Power over Coax Inductor

IEEE 802.3dm

September, 2025

Hiok Tiaq Ng, Kamal Dalmia Aviva Links Inc.

What was presented for ACT

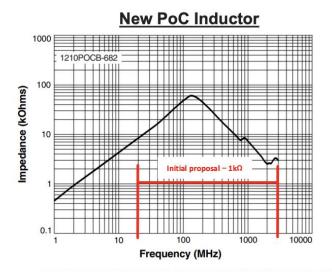
- This bullet states that the Old Inductor on the right-hand side has issues for broadband noise rejection
- Proposes the New inductor on the left.

Turned out, the New PoC inductor DOES NOT EXIST!!

Claimed NEW inductor

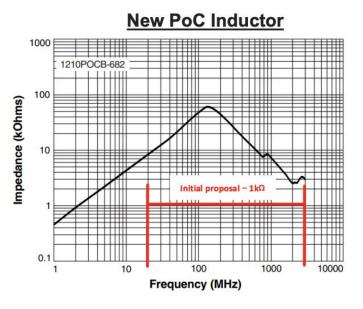
- "Claimed" NEW and "Actual" NEW are mismatched by a factor of 10x
- Old and Actual NEW are not very different from each other
- ACT presentation already stated that the OLD inductor is not sufficient.
